FCC C2PC Request Letter

SUBJECT: Class II permissive change for FCC ID: 2AVMJX5P

XPLORA Technologies AS respectfully requests a class II permissive change for FCC ID: 2AVMJX5P, original grant date 07/27/2020.

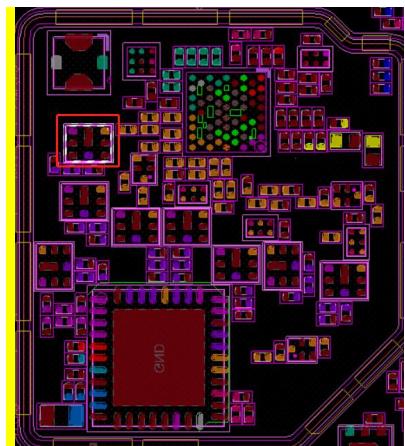
1. Turn off band12 and turn on band 20 through software and no rf parameters change.
2. No change of schematic and PCB Layout, just Replace the duplexer of band12 with the duplexer of band20, below mark red frame. no impact on EMC and SAR. (The FCC ID number: 2AVMJX5P is number change from FCC ID: 2AVMJX5PE, the FCC ID: 2AVMJX5PE is the original, so the FCC ID: 2AVMJX5PE Report as the C2PC original report.)
